**Saddleback Ridge Wind, LLC // Natural Resource Protection Act
(NRPA) and Site Location of Development Act applications**

- Licensee Exhibit 10
Review of Saddleback Ridge Wind Project Visual
Impact Assessment by James F. Palmer
(January 21, 2011)

**Review of the
Saddleback Ridge Wind Project
Visual Impact Assessment**

January 21, 2011

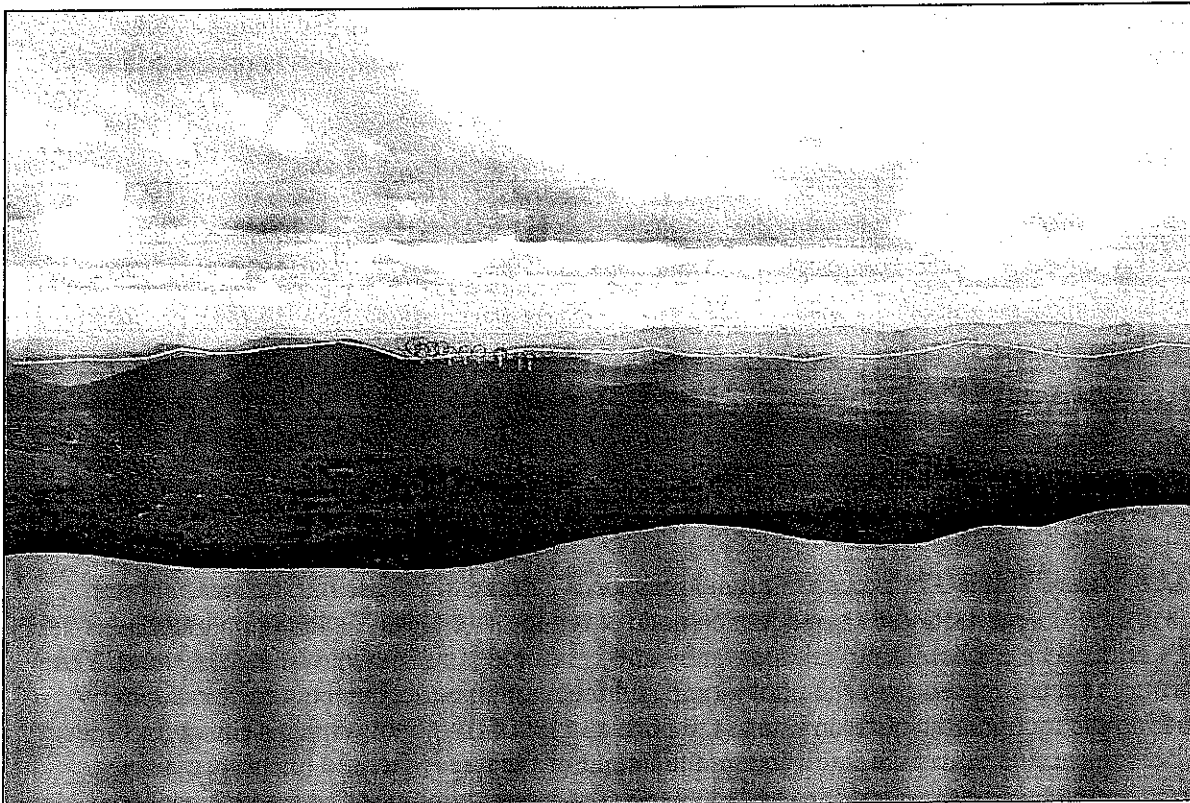
Some limitations of ArcScene visualizations are illustrated in Visualization 1. The turbines in the visualizations are always dark, though the actual turbines will be a light gray and will typically appear this way in the landscape. The mountains beyond the 8-mile study area are not represented in the visualization, though they are in the photosimulation. This is important, because they provide a background that reduces the perceived contrast and visual impact of the turbines. Another limitation of visualization is that they rely on GIS data that is too coarse to portray the finer resolution perceived in the foreground. The dark green wash that covers the lower right third of the page is foreground vegetation, which the photograph used for the simulation clearly shows does not obscure the view. However, a knowledgeable viewer can acknowledge these limitation, and still conclude that Photosimulation 1A appears to be an accurate representation.

Figure 2. Even in this view from across the intersection, it appears that the North Jay Grange will block views of the turbines.

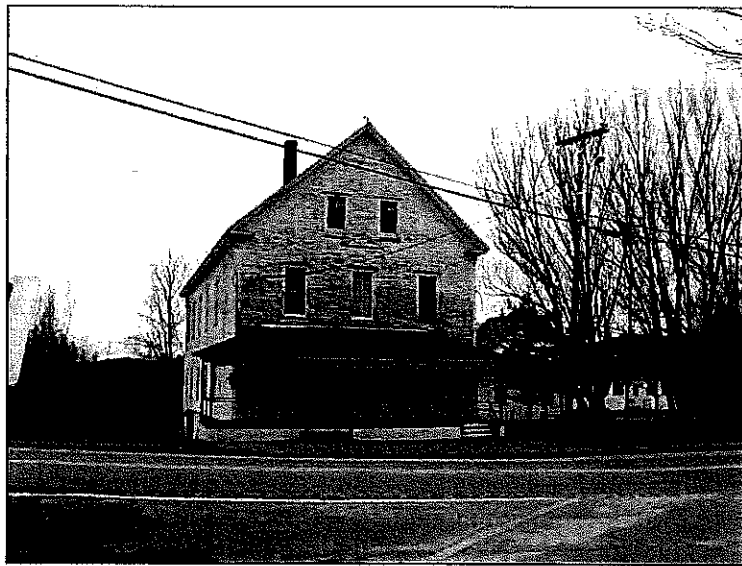
3.2.4 North Jay Grange Store. The North Jay Grange Store is private property, and while the building may still be used for social purposes, the “Grange Store” seems to be closed and the signs on the porch roof removed. There are no indications of public access or use of the grounds behind the building where views may be possible. The building will block views of the project from the normally accepted “public space” (e.g., the street in front of the building, the porch, and the entry), as shown in Figure 2. No visual clues (e.g., a worn path to picnic tables and fire pit) were observed to suggest that

there was public use of the area behind the building where there may be views. The standard procedure when conducting a VIA is to evaluate only outside views; while the project may be visible from inside the structure these views are not normally evaluated.

Figure 4. This image contains three components, the photograph used in Photosimulation 5A, the draft drawing of the turbines from WindPRO, and the view as represented in Google Earth. *Source:* TJD&A.

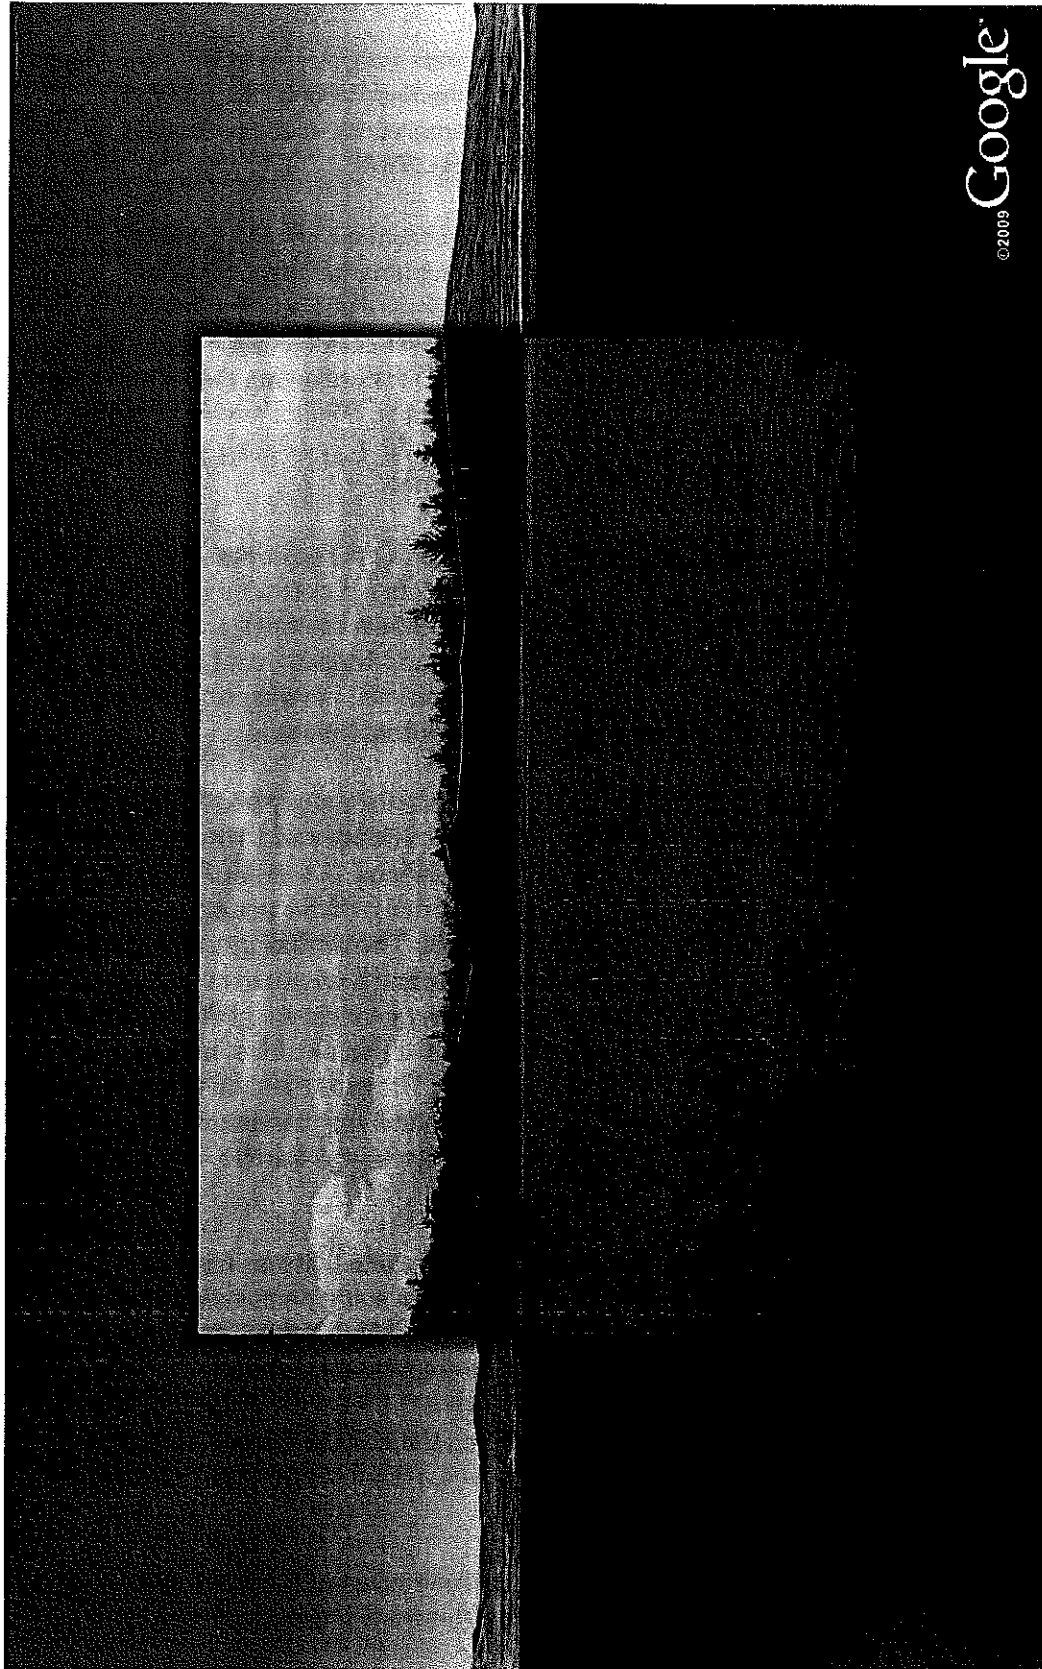
Halfmoon Pond provides an example of the difficulties of preparing visual simulations. From this viewpoint, the trees on the opposite shore are still within the foreground. The only distant landscape element that is visible through these trees is a small portion of ridgeline, believed to be part of Saddleback Mountain. The difficulty is that it takes at least two well defined common points, and preferably three or more to properly register two images. Figure 4 illustrates how TJD&A uses Google Earth to verify the location of the turbines within the photosimulation.

Figure 4 contains three components, the photograph used in Photosimulation 5A, the draft drawing of the turbines from WindPRO, and the view as represented in Google Earth. The ridgeline from the WindPRO drawing corresponds well to the horizon line in Google Earth, indicating that they are properly registered. The small portion of Saddleback Mountain visible in the photograph is located match the slope near the peak, though perhaps the WindPRO ridgeline is below the bit of ridgeline in the photo. In addition, the waterline of the photo seems higher than it is in Google Earth. This could be because of real differences in water level, or slight differences in the viewpoints used for the photo and Google Earth, or the photo may be improperly scaled. If the photo were a bit larger, bringing the two waterlines together and retaining the registration Saddleback Mountain’s slope, then the tree line would be slightly higher and perhaps screen the turbines slightly more than represented in the Photosimulation 5A.

There are additional ways to check the reasonableness of the photosimulation. For instance, all twelve turbines would occupy approximately 12° in the photo's 37.5° field of view, or approximately a third of the photo's width. This is the approximate relationship visible in Figure 4. A line-of-sight cross-section drawn from the viewpoint to the highest turbine would also help understand the potential for the project to be visible. It may be important to use vertical exaggeration or have a detailed blowup to show vegetation height effects the screening.

In conclusion, Halfmoon Pond is a difficult viewpoint from which to create a simulation with the procedures used in the VIA. However, TJD&A applied the method as skillfully as could be done under the circumstances. In addition they used Google Earth to check these results. The width of the visual field occupied by the twelve turbines in the draft WindPRO drawing is in proportion to the total width of the photograph, indicating that the photosimulation is properly constructed. A line-of-sight cross-section was requested to increase confidence that the simulation accurately portrayed the extent of turbine visibility from this location. It was provided as part of the VIA Supplemental Information (TJD&A 2011, page 15). Overall, Photosimulation 5a appears to be a reasonable representation.

6. The quality of the photosimulations generally appears to be high. However, the simulation of the view from Halfmoon Pond presents a difficult situation for the method used to create the simulation (i.e., use of the ridgeline to register the WindPRO drawing of the turbines to the simulation photograph when only a single small portion of a slope can be seen in the photograph). In this case, both Google Earth and ArcScene were used to validate the simulation and it was found that any possible inaccuracy would be small and unlikely to significantly effect the evaluation of scenic impact. A carefully constructed line of sight cross-section using measured heights for the effective screening vegetation would settle the question. **In situations where there may be a reasonable doubt about the accuracy of a photosimulation, the VIA should provide corroboration of its validity.**
